Preliminary Drainage Study

West Grove

San Bernardino County, California

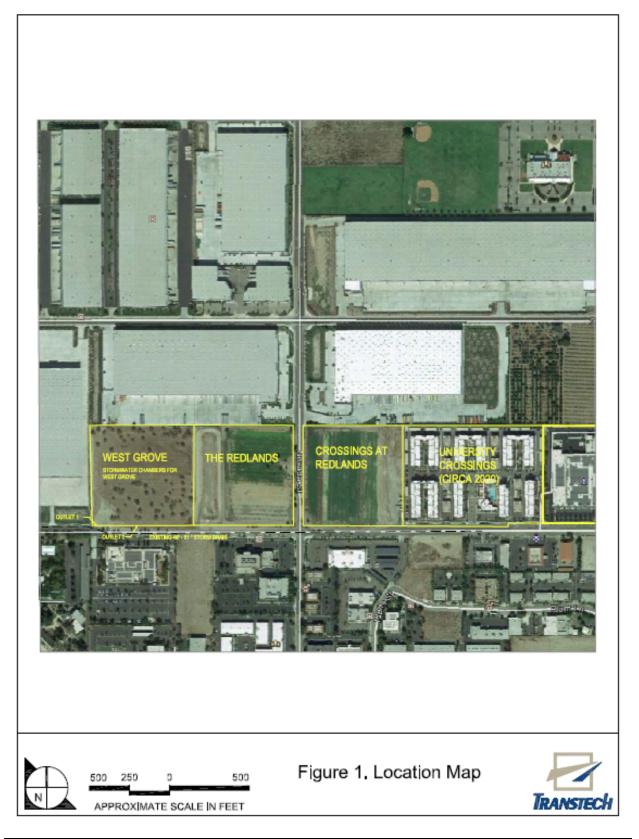
Calculations for each area not provided and will be required on final report.
